Arctic Bay Harbour Development

Community Consultations

20 December 2019

307071-01306 – 00-PM-REP-0002

Current Design Options – Option 1

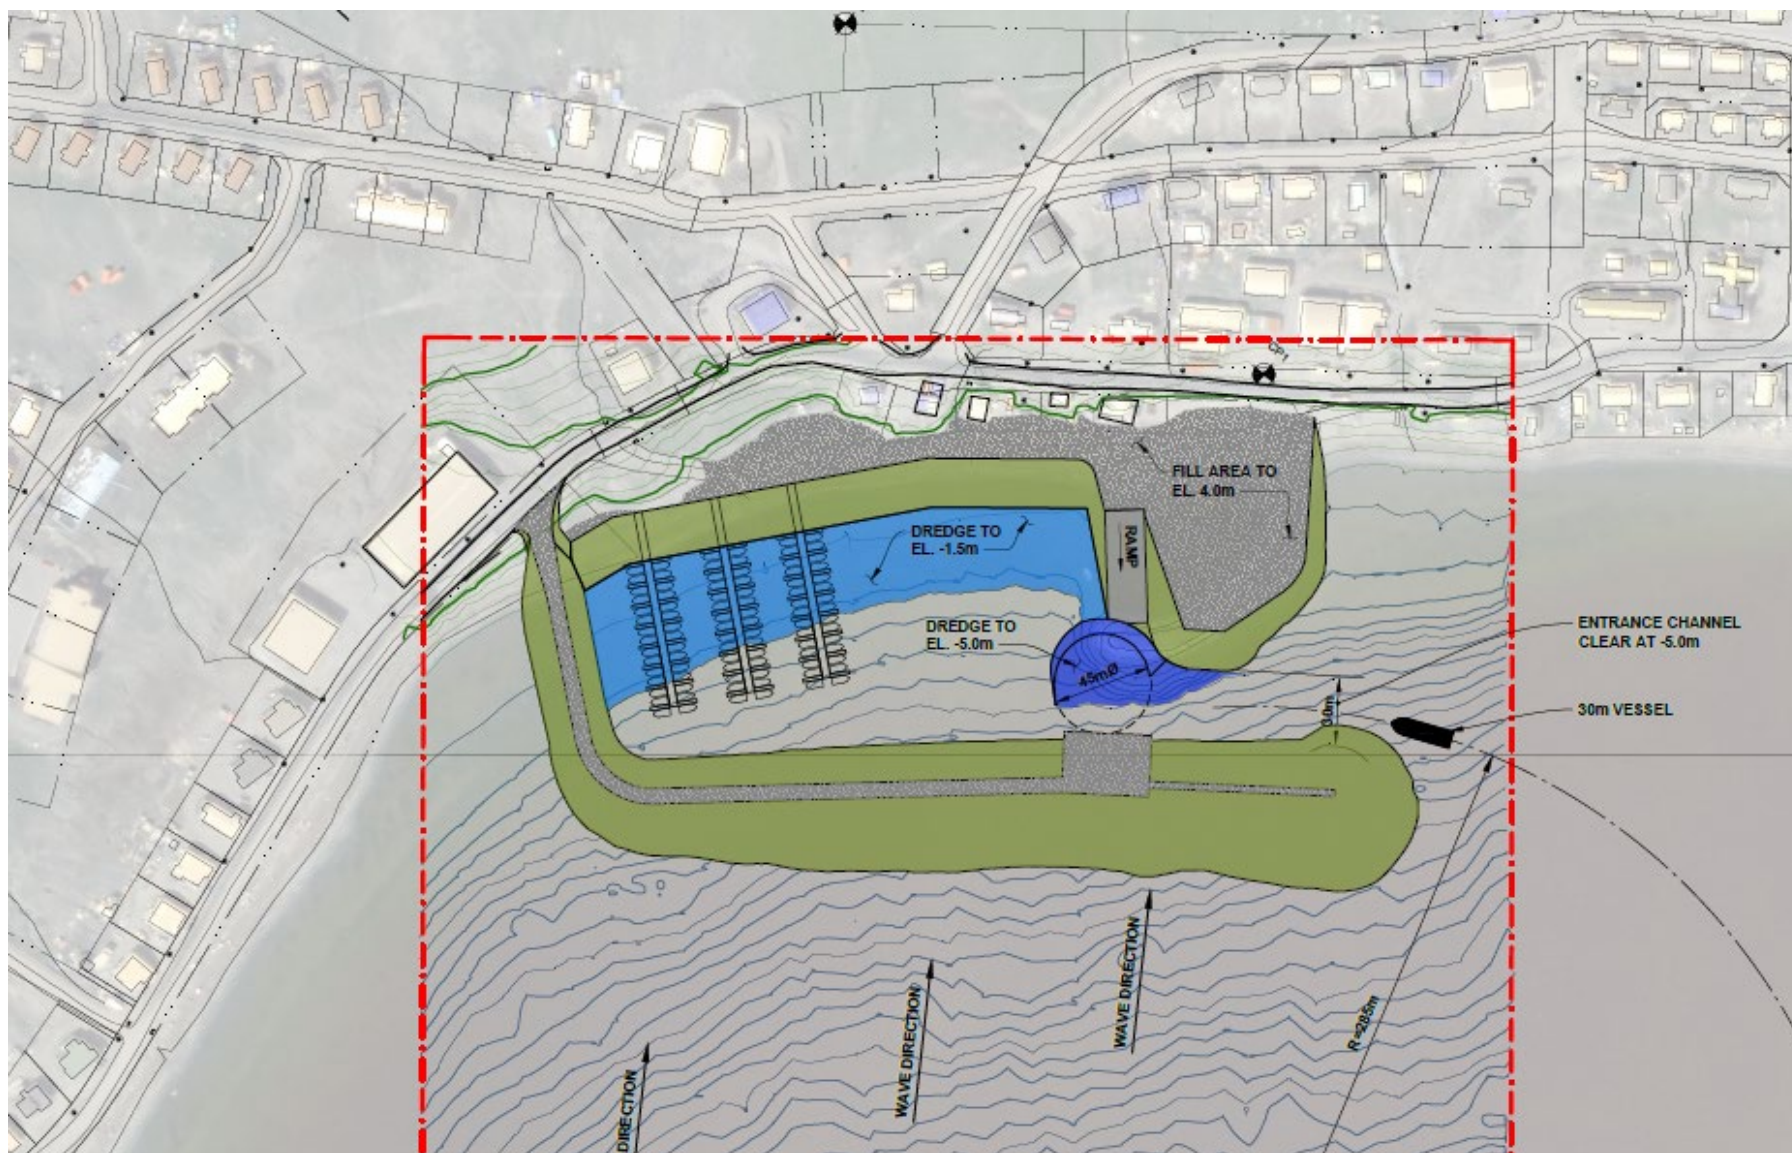
- There are serious safety concerns with sealift. It causes too much congestion. We need to move sealift. or ensure the design accommodates for it.
- Option 1 provides a good area for sealift. storage. Hunters will want to be able to store boats/trailers in the sealift. area laydown when sealift. is gone.

- Option 2 doesn't seem to provide as much sealift. laydown area. Option 1 is preferred over Option 2 for this reason.
- The entrance in Option 3 seems very vulnerable to waves. There are strong SE storms. Option 1 preferred for this reason.

- Large storms will ruin or completely wipe out the small road on the breakwater in Option 3.
- Whether it is designed to be a road or not, if people can, they will use it as a road. Option 1 preferred because you can drive on the breakwater.

- Consider moving the sealift unloading and laydown area over to the right in Option 1.
- Concern with sealift offloading area in Option 1. Despite the increased laydown area provided it will still be too dangerous to have sealift operating in the area. Too much traffic and congestion. Public safety hazard. Also, an elder's residence is right at the laydown area, the elder's access would be limited while sealift is in. Hunters access is also restricted to get to their boats during sealift. Sealift must move to the industrial zone.

Current Design Options – Option 2

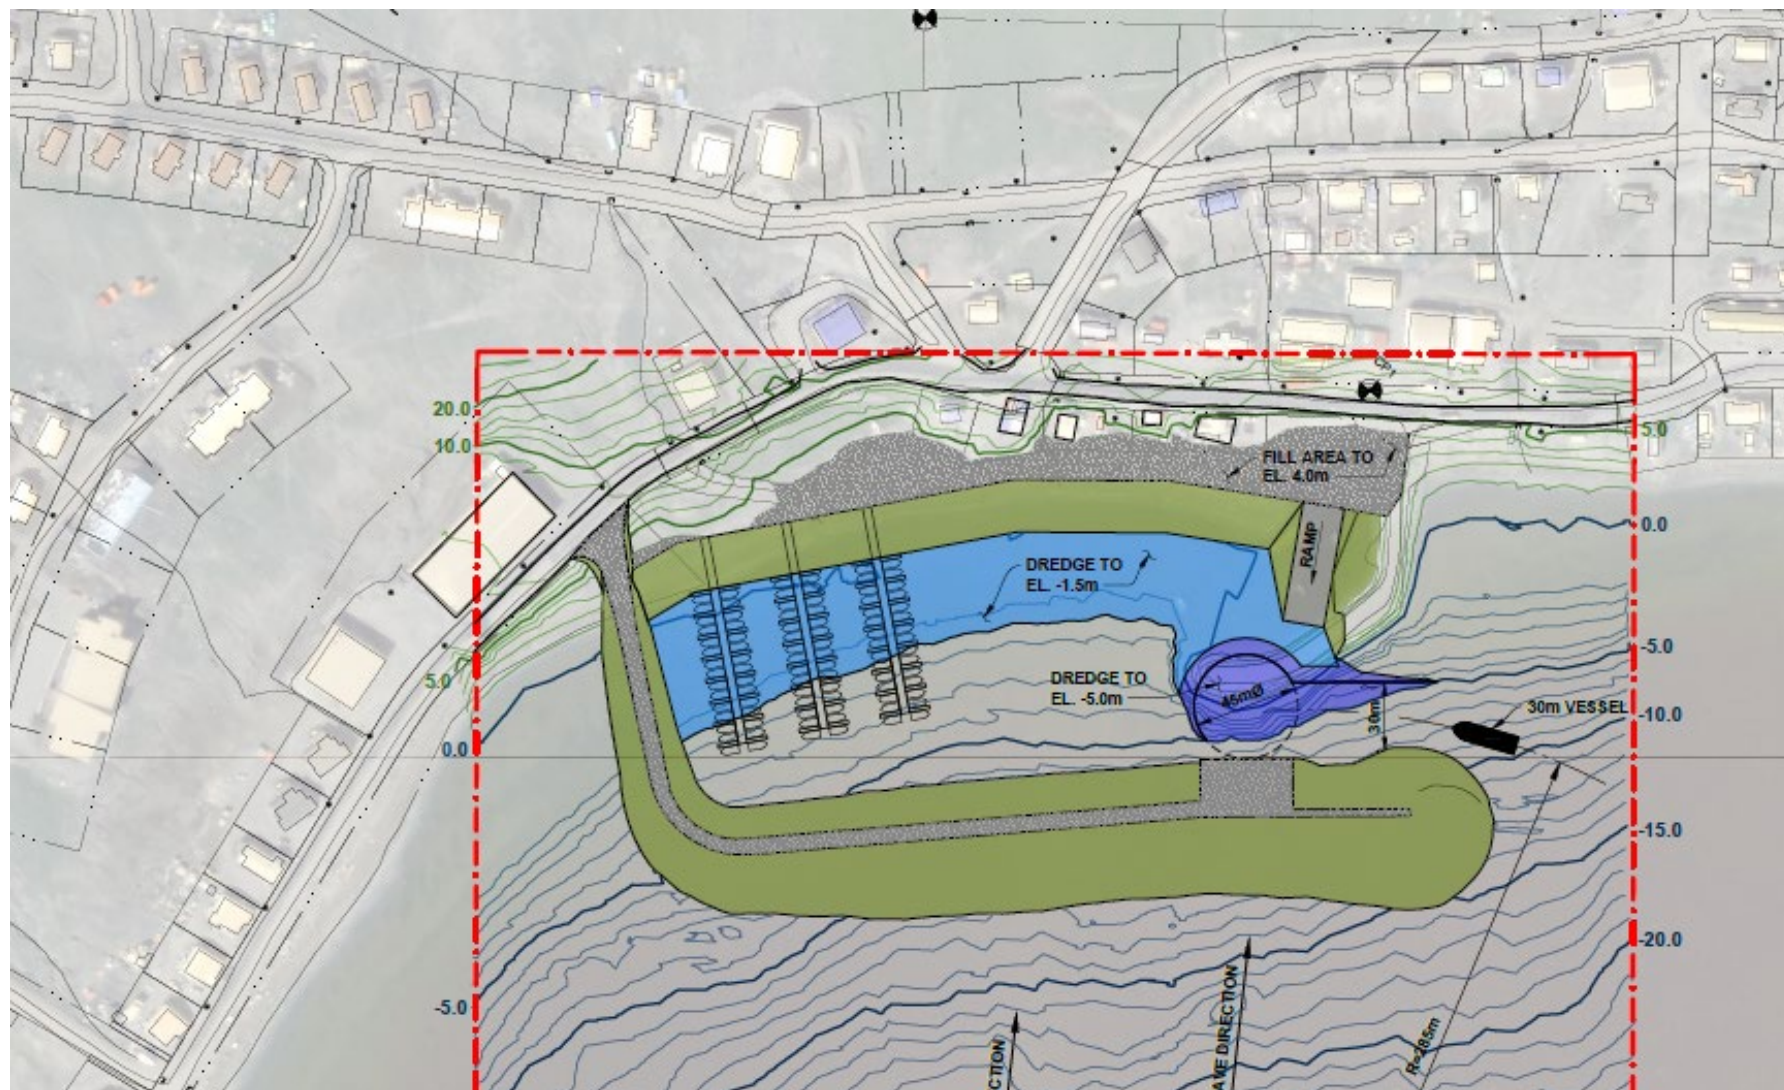
- Option 3 is the most vulnerable, the entrance is too exposed and there will be too much wave action in the harbour
- Option 2 is currently preferred but this depends on whether sealift will be moved or not. Option 2 is the best design for dealing with wave action.

- Change the ramp location in Option 2.
- Request installing a boat ramp at Victor Bay and at Oulouksione Point on the Adams Sound side of the point. A boat ramp in this location would allow longer access to open water (Arctic Bay becomes frozen well before Adams Sound)

Current Design Options – Option 3

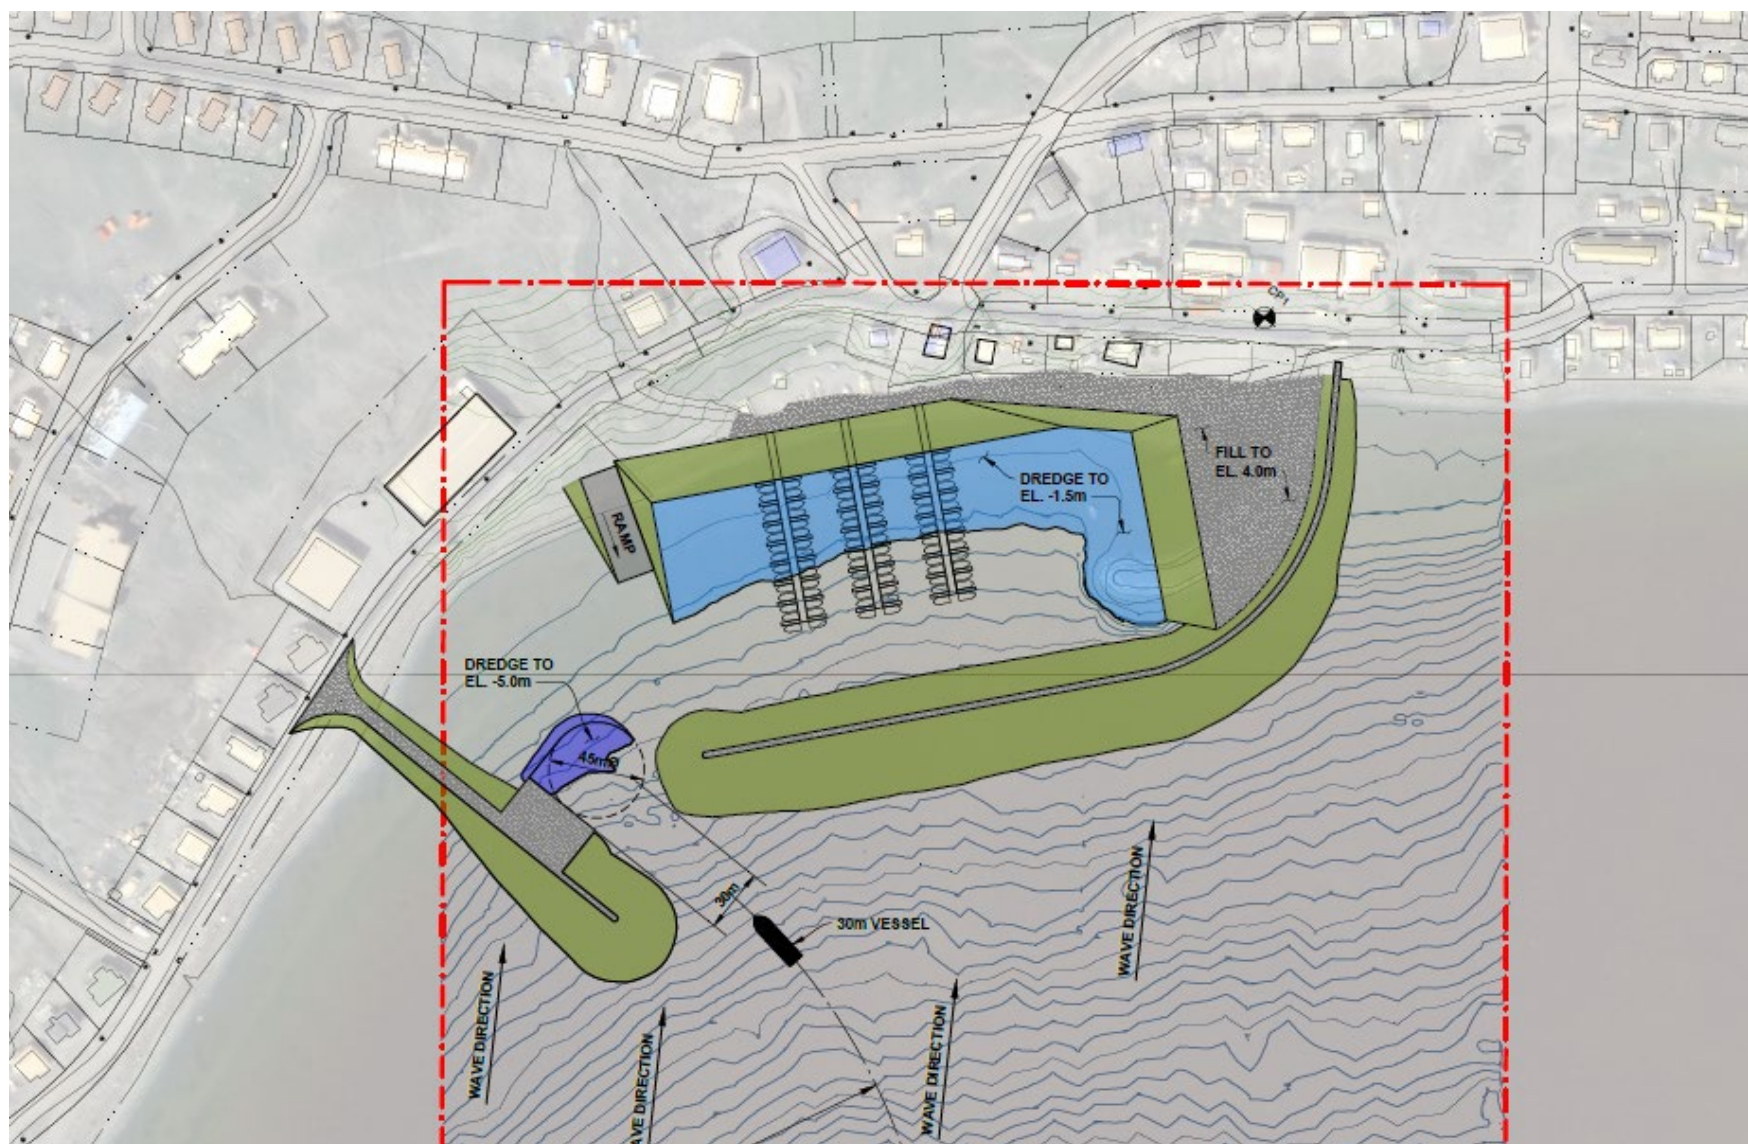
- Option 3 is not supported by the hunters. They believe, as designed, that it will be dangerous to navigate the entrance during storms.

- Option 3 was marked up to show a better tie in to the road and a more robust breakwater shape to deal with vulnerable entrance
- The access road in Option 3 is very high, it will need to be diverted.

- The strongest winds these days come from the direction that will cause wave action in the harbour in Option 3. Even if the breakwater is extended as marked, the harbour will experience too many waves.
